CALIFORNIA COASTAL COMMISSION

STAFF REPORT: REGULAR CALENDAR

APPLICATION NUMBER: 5-01-179

PROJECT DESCRIPTION: Demolition of an existing 5-unit apartment complex and construction of a new 4-unit condominium complex with a subterranean parking garage, hardscape and landscaping on a coastal blufftop lot. The project involves grading of approximately 796 cubic yards of material for garage excavation and site preparation. The project also involves approval of a Tentative Tract Map for the creation of condominiums.

PLOT PLAN / ROOF PLAN

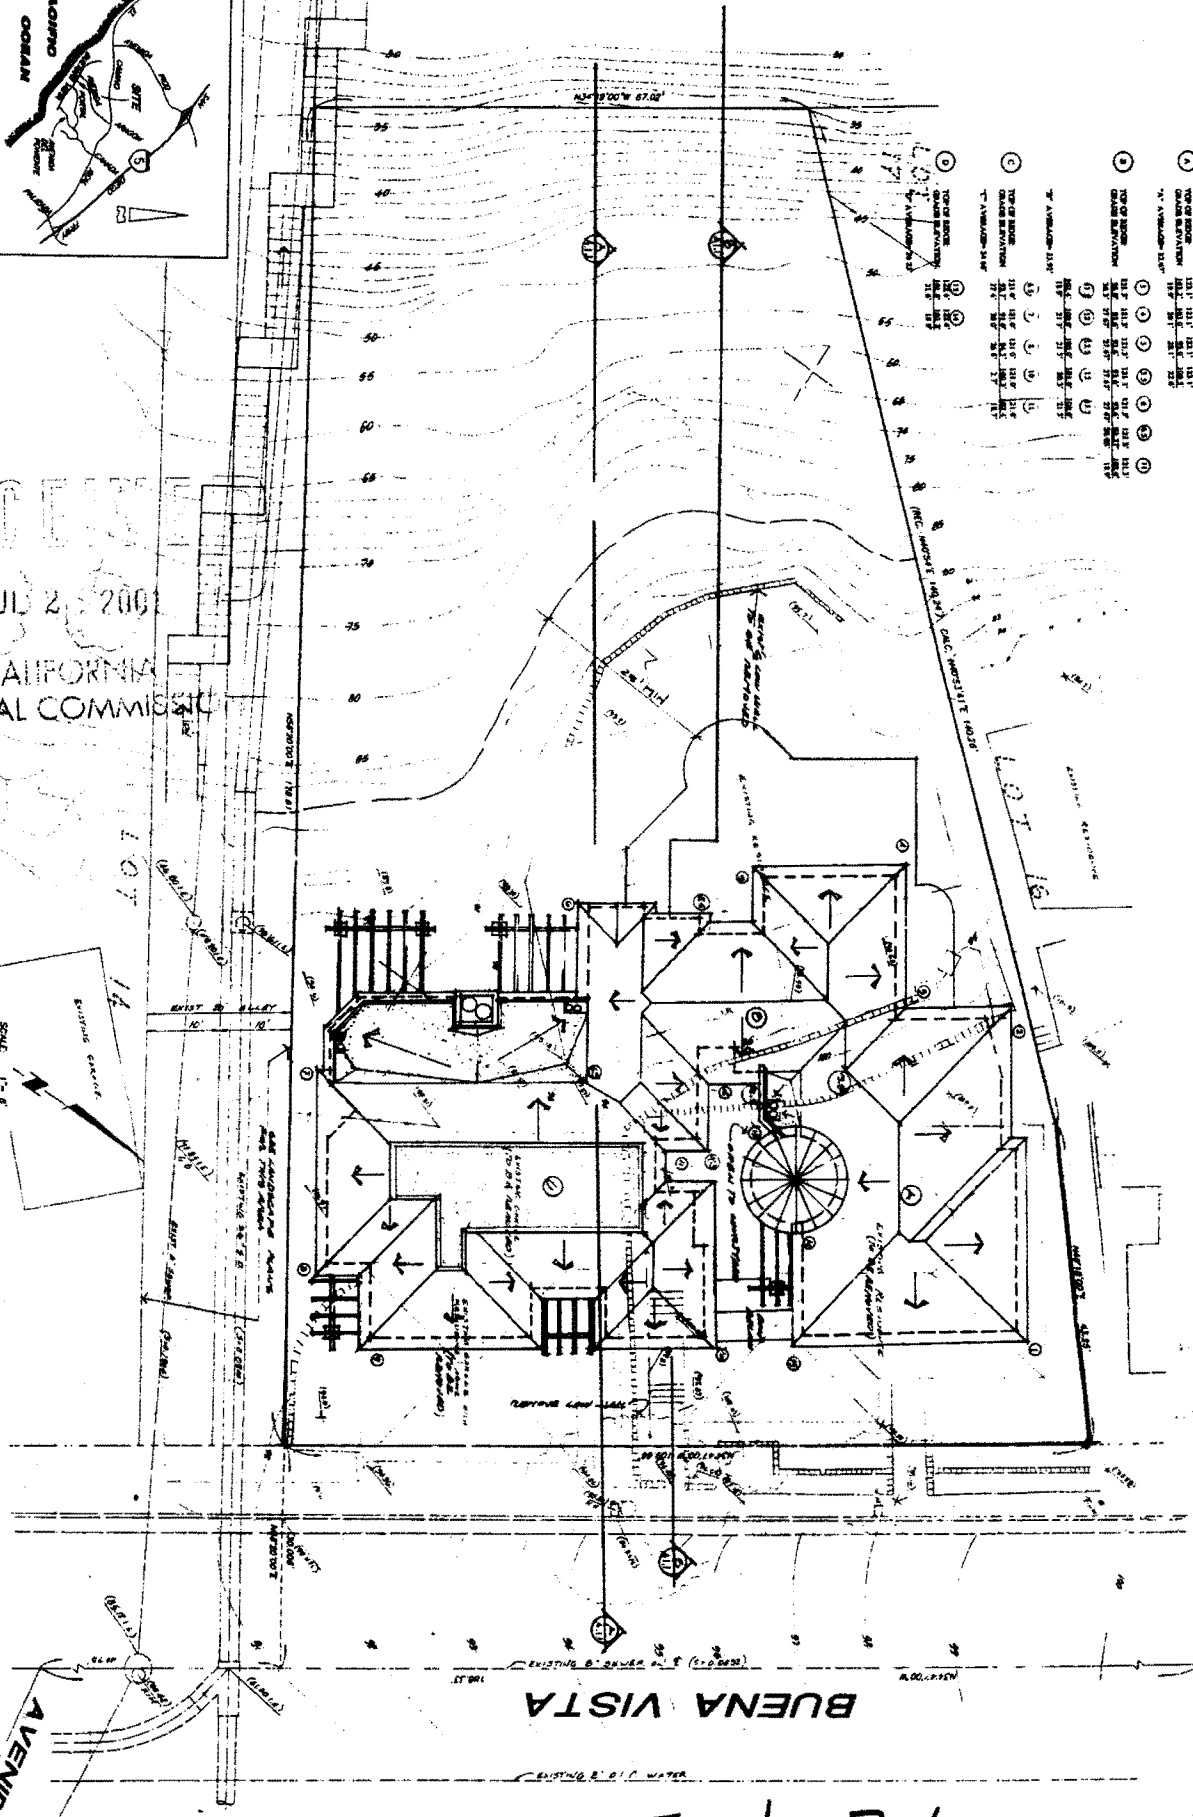
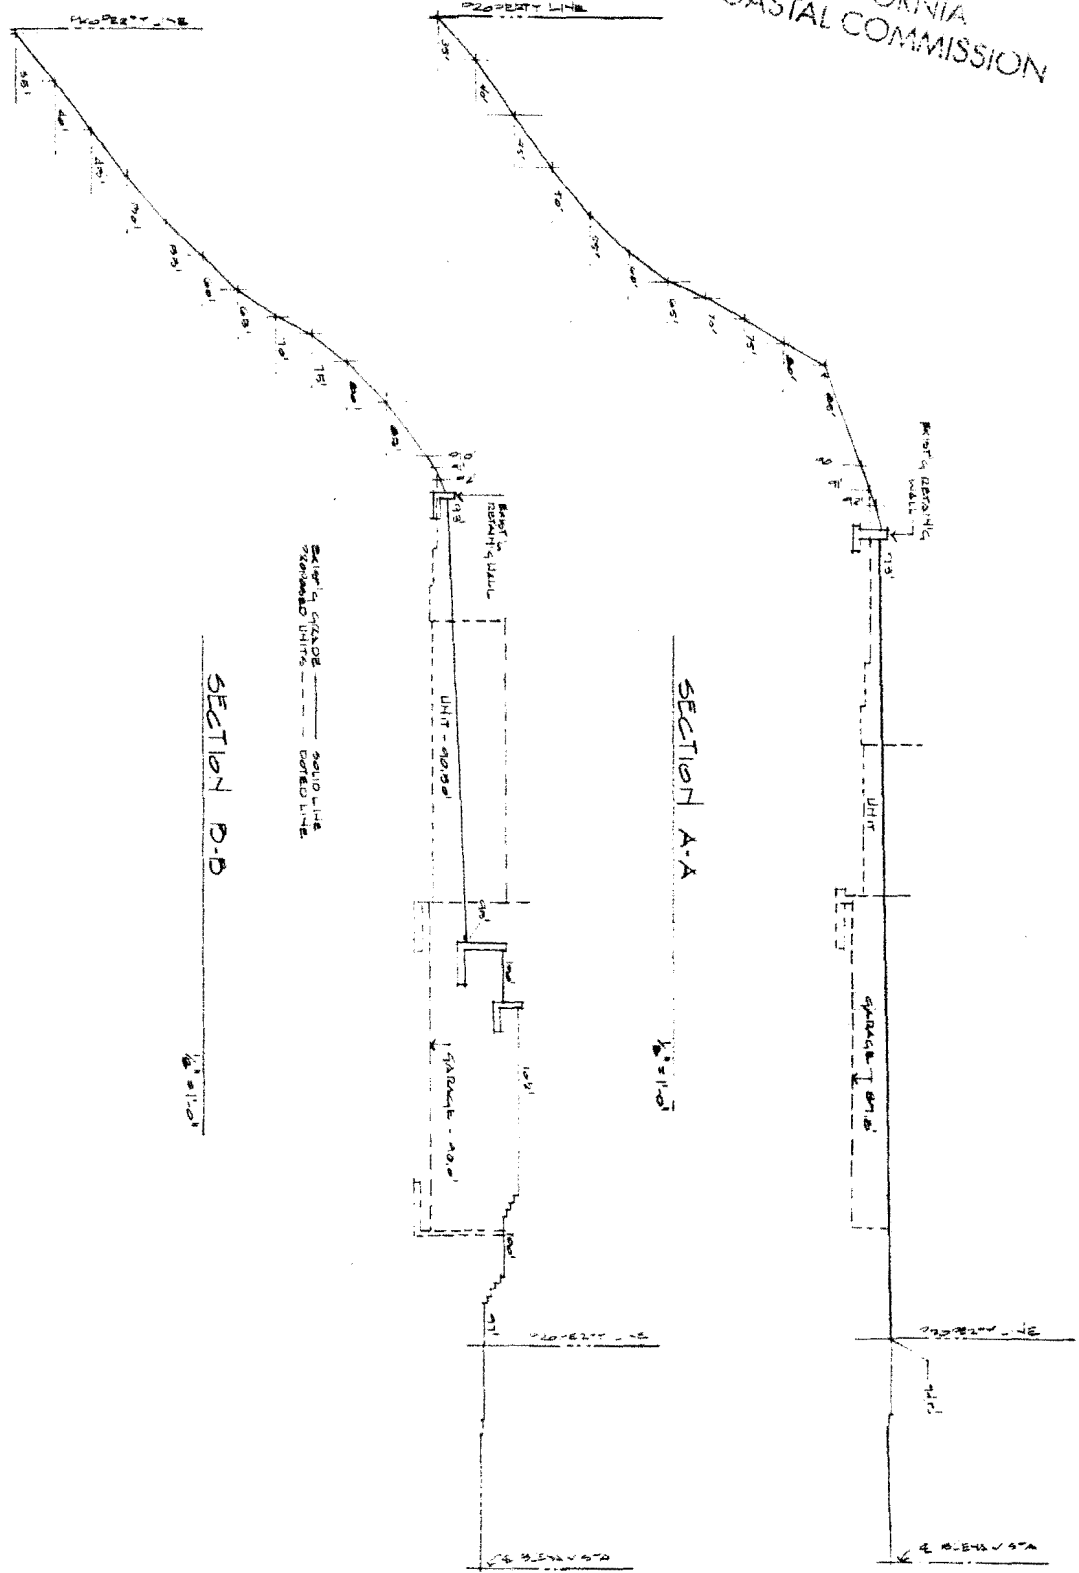
The project plans contend that the proposed condominium will be set back in accordance with the 25-foot structural setback specified in the City's certified Land Use Plan (LUP). In addition, the plans show the proposed concrete patio to be sited in accordance with the typically applied 10-foot hardscape setback. Therefore, theoretically, all new development is shown to conform to the minimum setback requirements of the LUP. This reflects a greater setback than was previously applied at this site, as the existing "pre-Coastal" apartment complex is located

While the plans submitted show all new development to be set back from the bluff edge in accordance with the requirements of the LUP, the bluff edge is improperly depicted on the project plans. As such, the structural and hardscape setbacks are improperly depicted. Whereas the applicant depicts the 88-foot contour as the edge of bluff along the southernmost (downcoast) portion of the site, the Commission's methodology places the bluff edge at approximately the 90-foot contour. Using the 90-foot contour to establish the minimum bluff setback, a portion of the proposed structure encroaches approximately 10 feet into the required 25-foot setback and the proposed concrete patio encroaches approximately 4 feet into the typically applied 10-foot hardscape setback.

CROSS SECTION B - B'

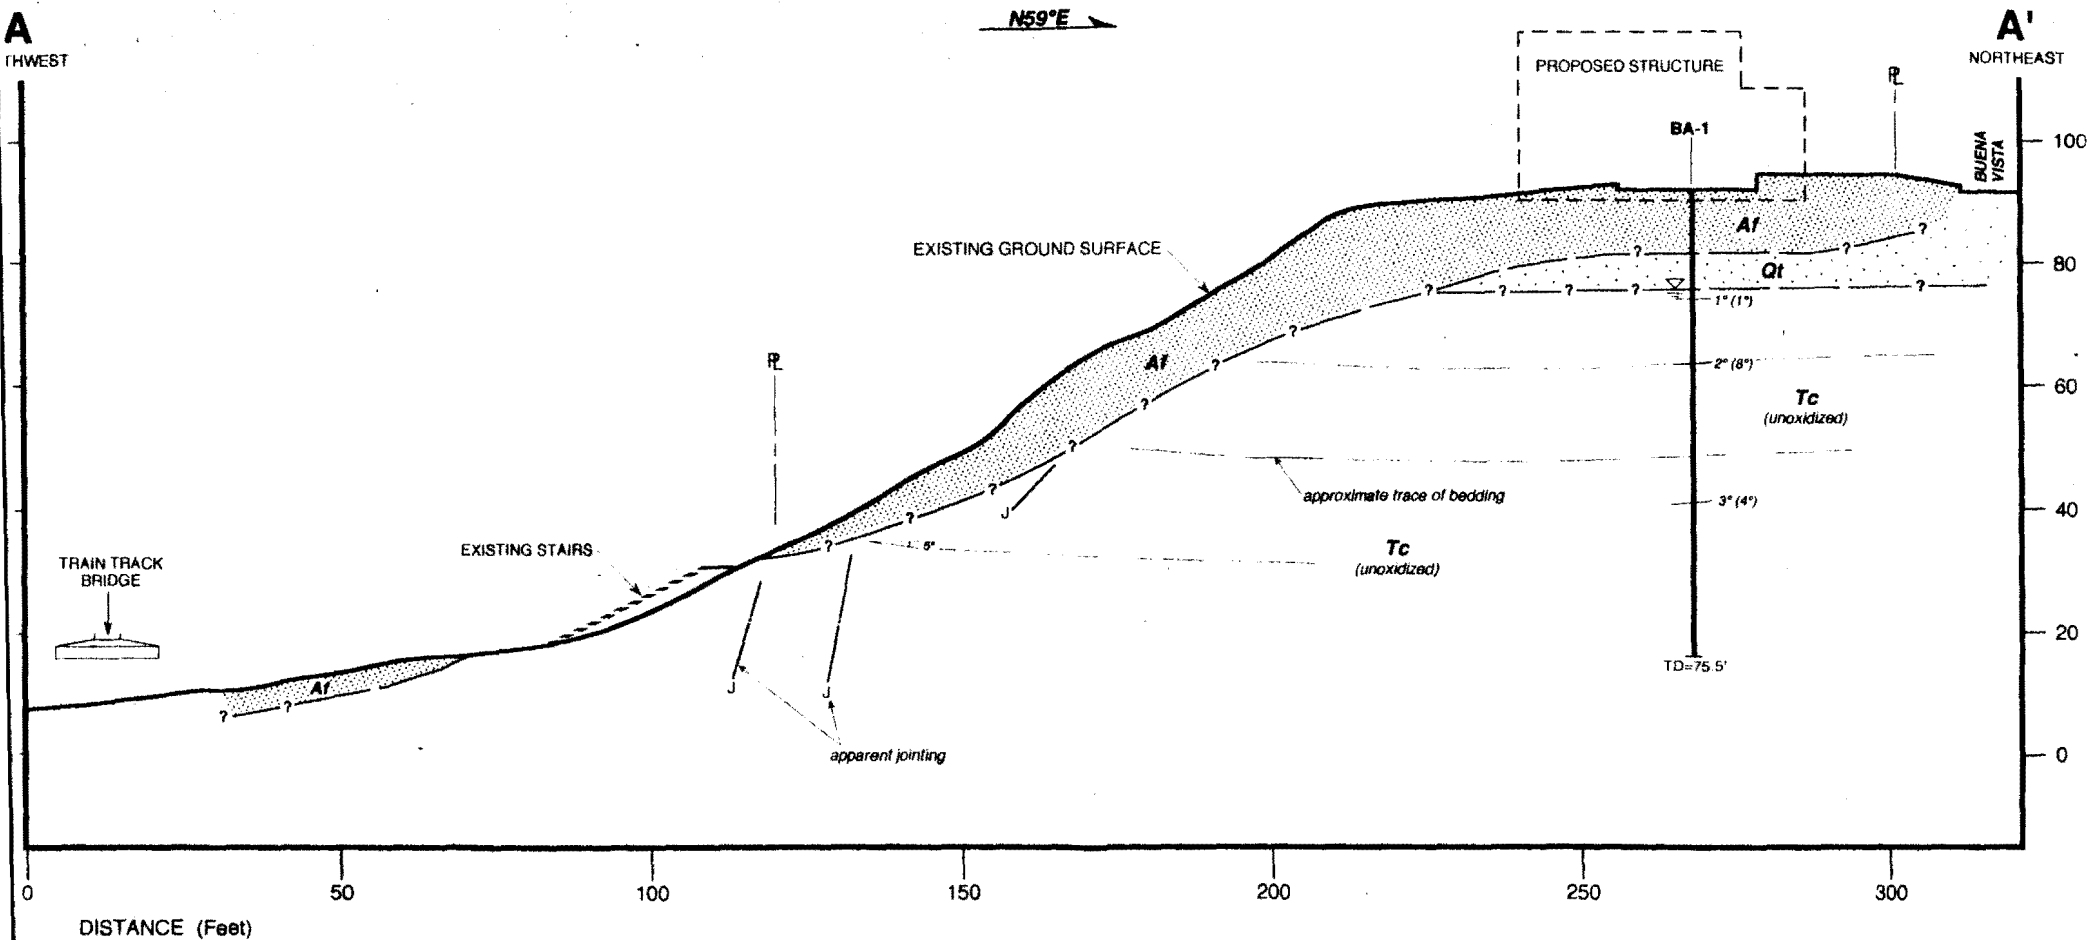
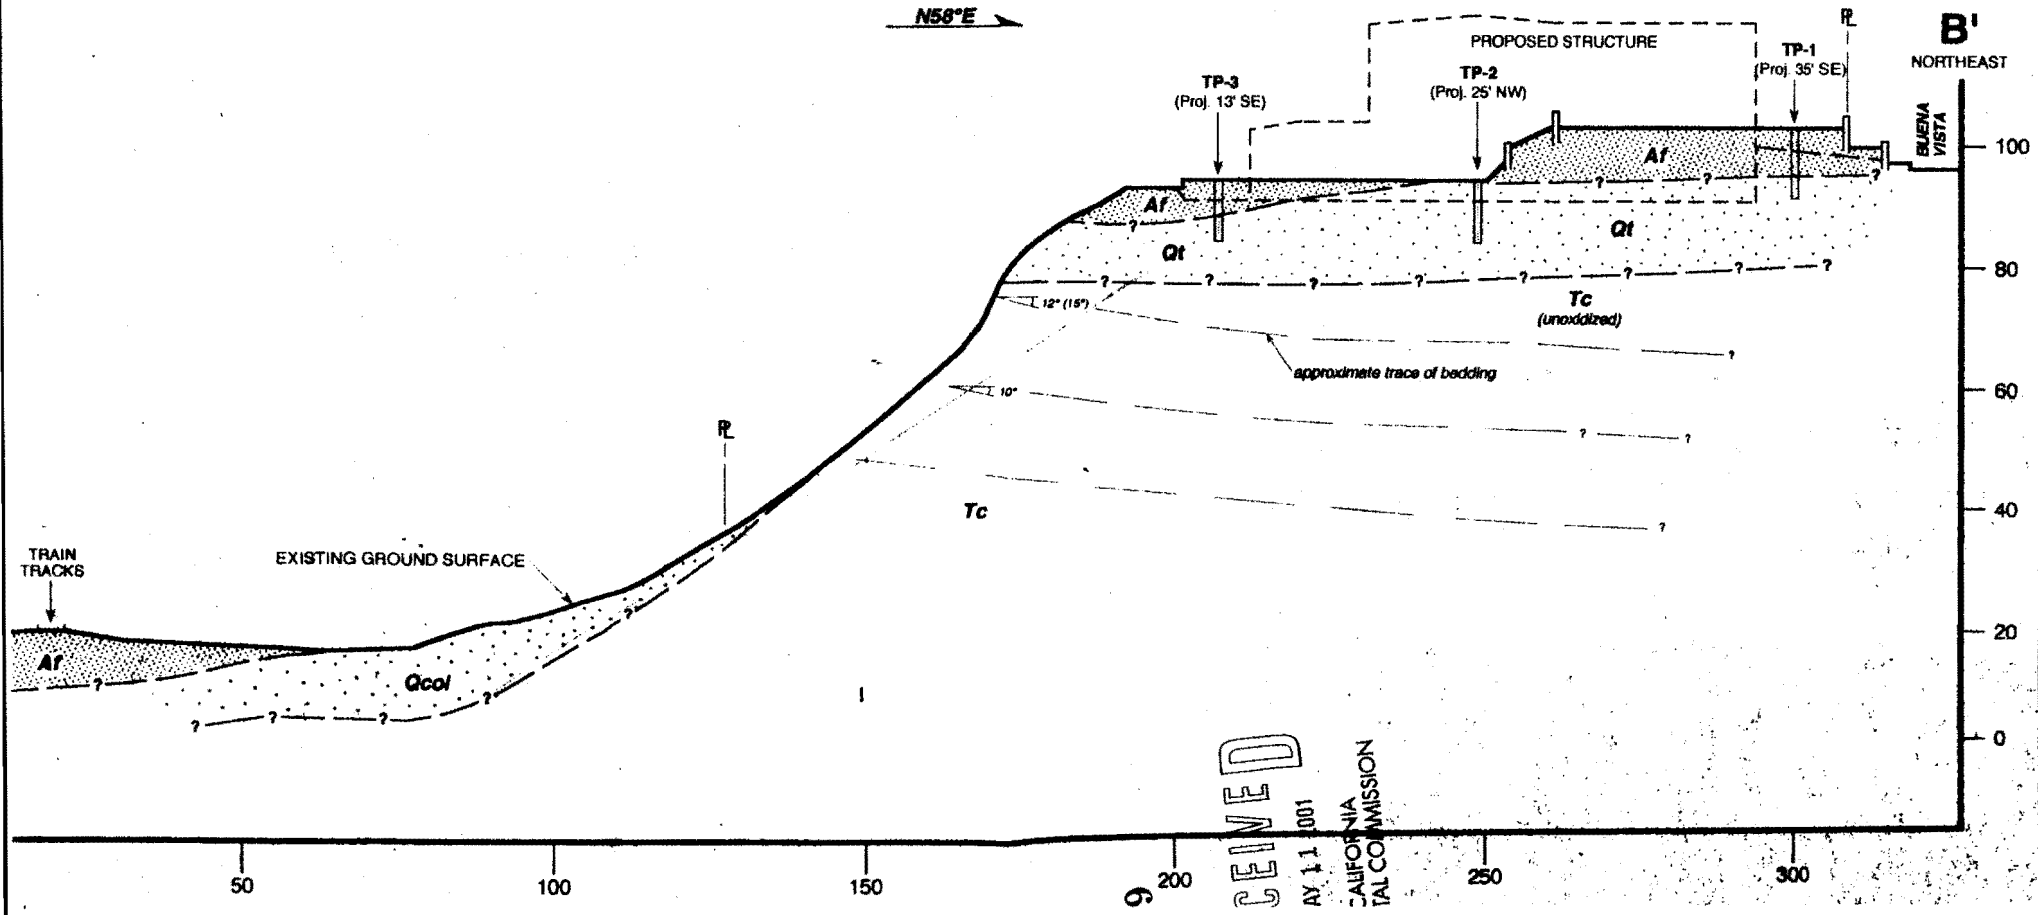
The geotechnical report describes the property as a roughly trapezoidal-shaped lot with existing residential structures where the developed portion of the site is situated on an elevated marine platform overlooking the Pacific Ocean. The undeveloped portion of the lot includes an approximately 80-foot high bluff that descends to the railroad tracks below. According to the consultant, the northwestern half of the slope is virtually unaltered bluff. The upper portion of the slope has an average slope ratio of approximately 1:1 (horizontal to vertical) with some portions as steep as 0.5:1 (horizontal to vertical). The lower portion of the slope is more gentle, descending at an approximate slope gradient of 1.6:1 (horizontal to vertical) to the toe. As stated in the geotechnical report, *"this portion of the slope is significantly different than the slope that lies within the southeastern portion of the property, adjacent to the public beach access. The coastal bluff edge recedes in this area, marking the location of a former stream that breached and recessed the bluff top."* Cross sections of the rear yard bluff are provided in Exhibit 5.

Nothing in the Coastal Act or its regulations stipulates that a coastal bluff need be unmodified by human activities to preserve its status as a coastal bluff. If the morphology of a bluff has been changed by prior grading, the only standard by which to establish the current bluff edge is as defined in the regulation. In reference (1), the coastal bluff edge is defined "as the former top of native terrace deposits, and excludes the presence of the existing artificial fill slope above." This is appropriate and consistent with previous Commission decisions – the presence of artificial fill adjacent – or even over – a coastal bluff does not change the location of the bluff edge from its pre-grading configuration, although the overlying fill may conceal the location of the natural bluff edge. However, a cut at the top of a bluff may very well move the bluff edge landward of its original position. Artificial fill overlying either the natural bluff edge or an artificial bluff edge created by a cut may make the location of the bluff edge very difficult to determine. This is the case at the subject site. After perusing the topographic survey (reference 2), the boring logs of test pits 2 and 3 in reference (1), the estimate of the terrace/fill contact on plate 2 of reference (1), and after visiting the site, it is my opinion that the bluff edge on the southern part of the site is approximately coincident with the 90 foot contour as depicted on reference (2). The geotechnical cross-section in reference (2) depicts a buried, inclined interface between the terrace deposits and the artificial fill that very likely represents either a cut slope at the top of the bluff face, or a rounded edge as described in the regulation cited above. Thus, it is possible that the actual bluff edge should be placed considerably landward of the 90 foot contour. In the absence of more definitive information, however, the present topographic form, used in placing the bluff edge at the 90 foot contour, seems most appropriate. Reference (3), a letter from the project architect, contains an assertion, unsupported by any argument, that the bluff edge should be placed at the 88 foot contour. Although this does represent the approximate contact between the fill and the terrace deposits on the bluff face, for the reasons outlined above this is not an appropriate point at which to place the bluff edge by the definition outlined in the regulation.
